AGENDA

President and Board of Trustees
Village of Arlington Heights
Board Room

May 13, 2019

- A. Election of President Pro Tem
- B. Arlington 425 - Highland/Campbell/Chestnut - PC#19-001
Planned Unit Development, Preliminary Plat of Subdivision,
Rezoning from R-3 to B-5, Land Use Variation to allow a Multi-
Family use within B-5 District, Variations

Job No: 18-127 Figure: 7A

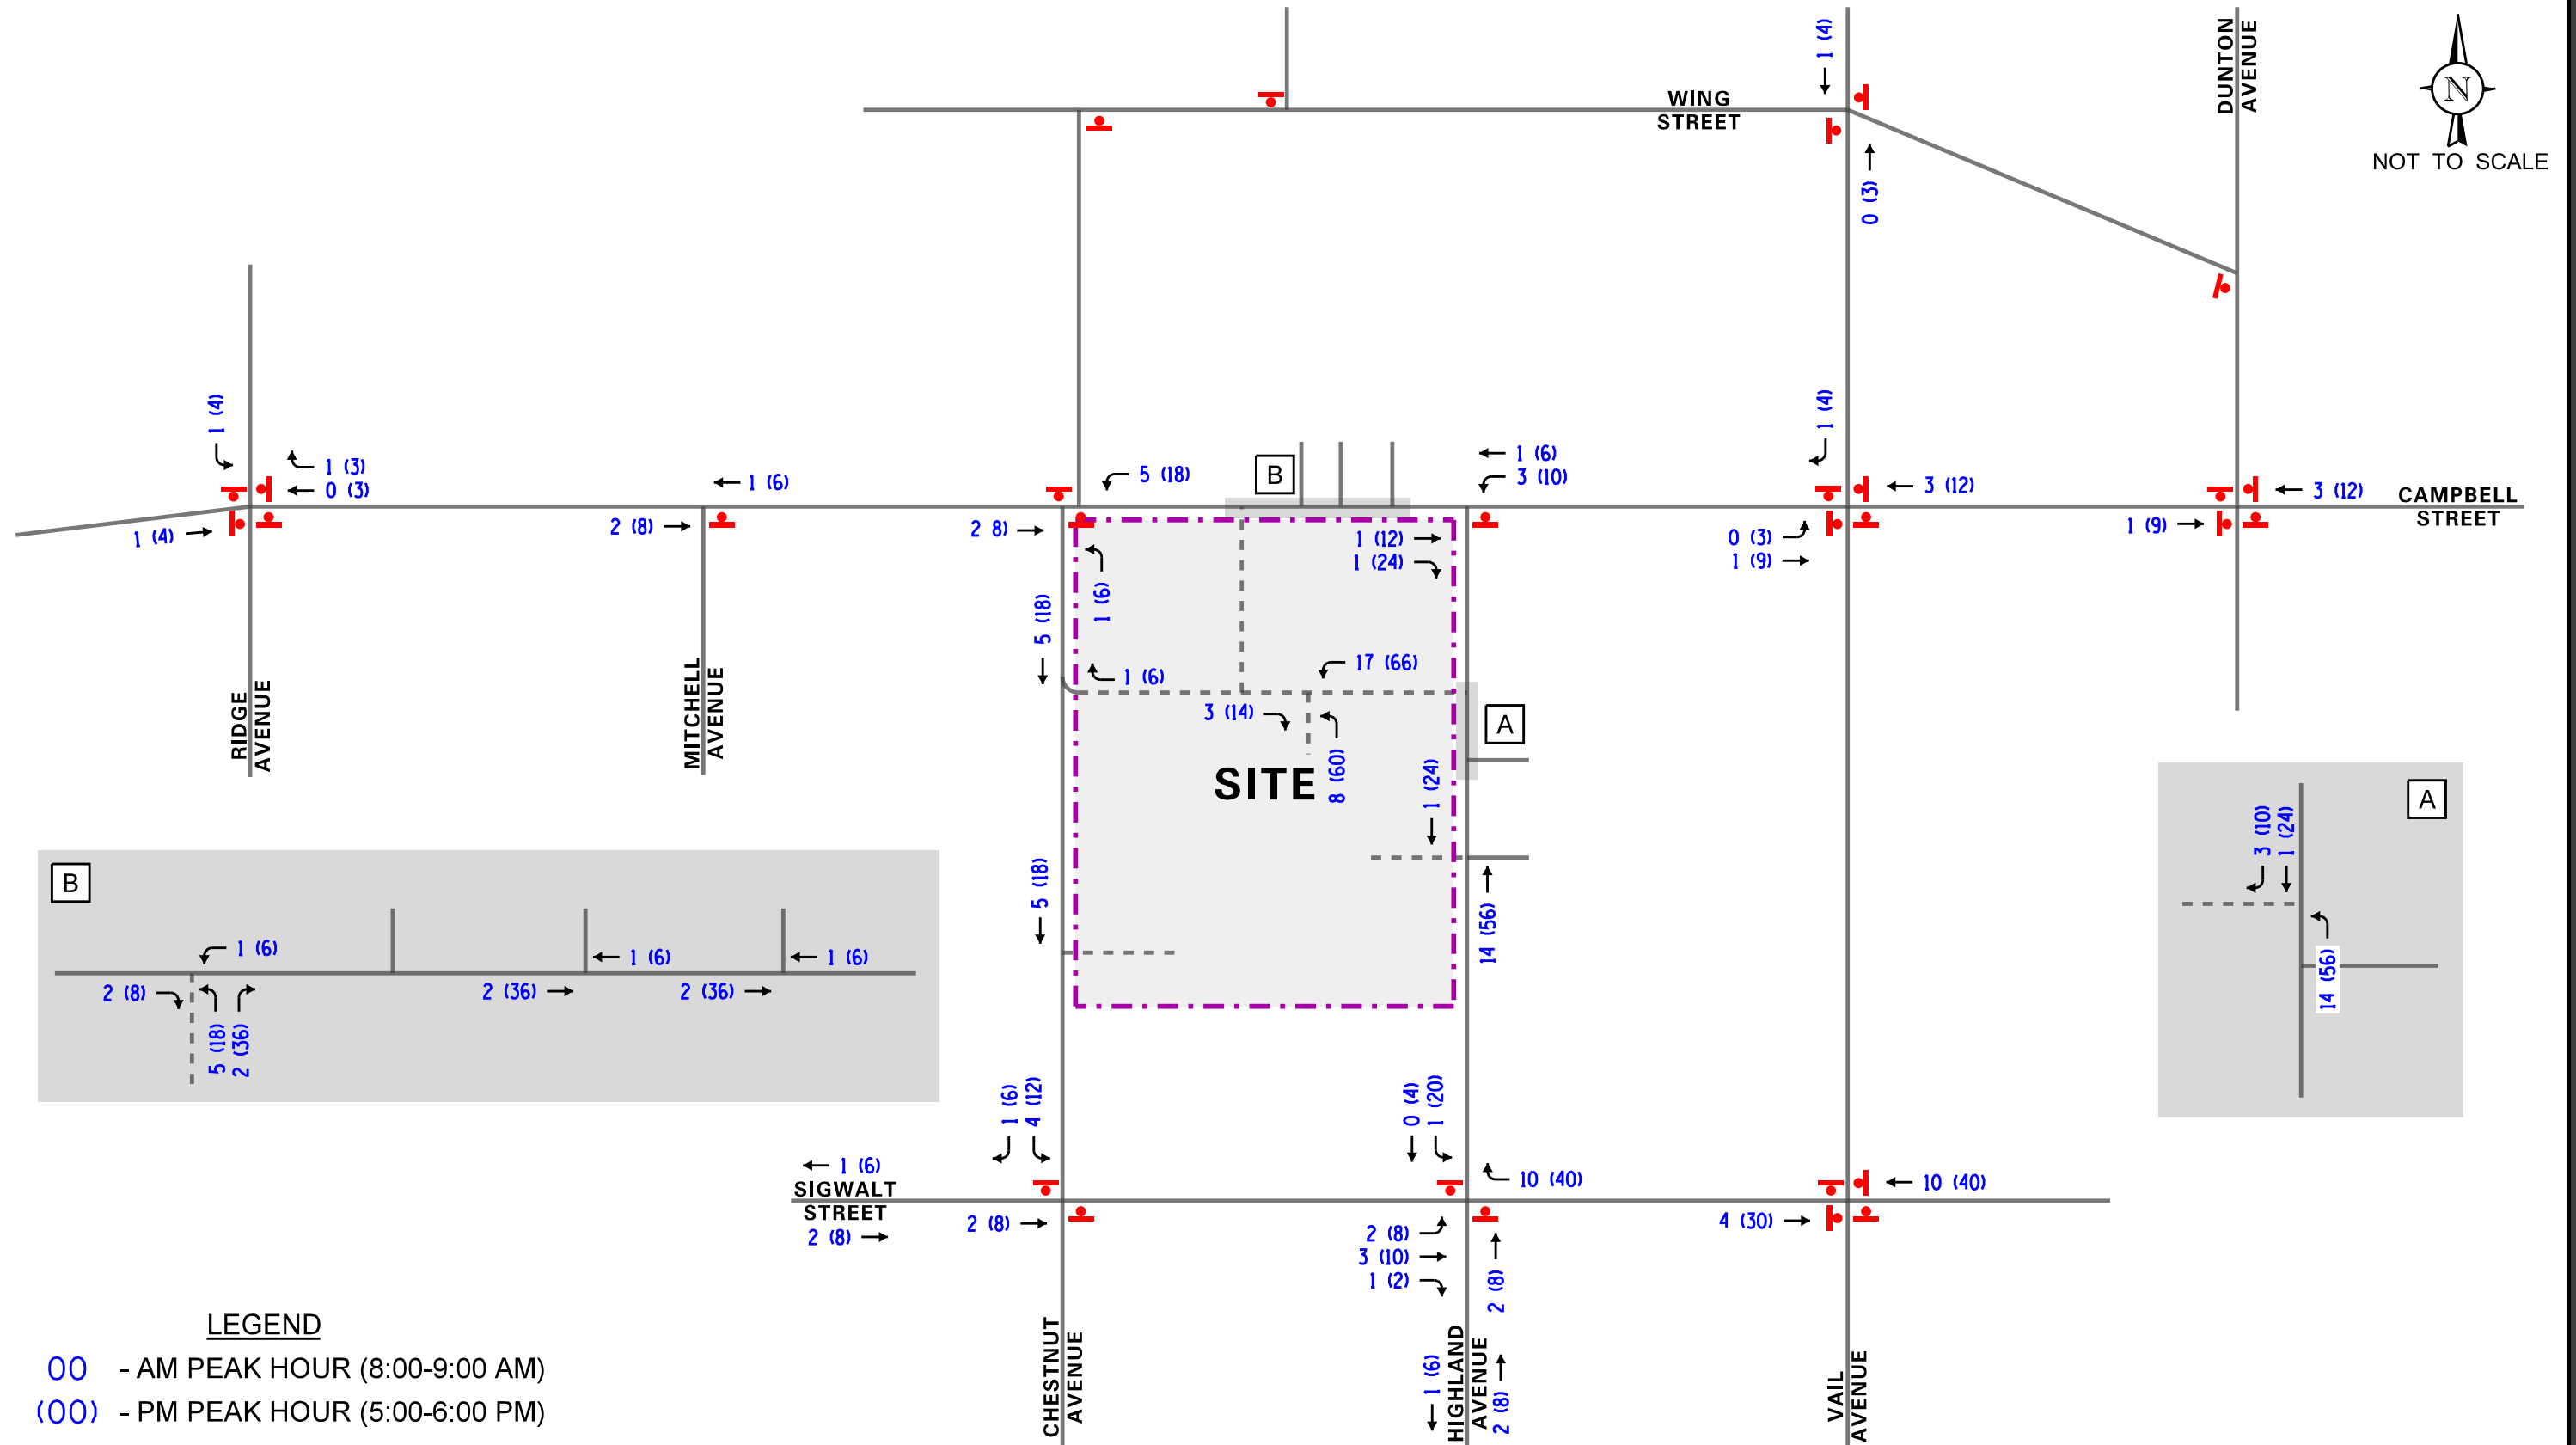
97. The response provided by the petitioner to comment #51 is not satisfactory. The last statement made suggests that the south Highland parking garage driveway volumes are higher than the driveway out of the N.W. corner of the Highland building. However Figure 7 does not support this contention.

97. The response provided by the petitioner to Comment #51 is not satisfactory. The last statement made suggests that the south Highland parking garage driveway volumes are higher than the driveway out of the N.W. corner of the Highland building. However Figure 7 does not support this contention.

Response: A majority of the residential traffic (approximately two-thirds) is estimated to use the exclusive residential southerly access drive on Highland Avenue. Please refer to Figure 7A located in the Appendix of the Traffic Impact Study which shows the assignment of residential traffic only. Please refer to Figure 7B located in the Appendix of the Traffic Impact Study which shows the assignment of non-residential

Response: The residential assignment (Figure 7A) included in the appendix of the Traffic Impact Study shows that approximately two-thirds of the residential traffic will enter from the southerly access drive off Highland Avenue. The Traffic Impact Study was revised with respect to volume balancing between intersections on Campbell Street and Highland Avenue.
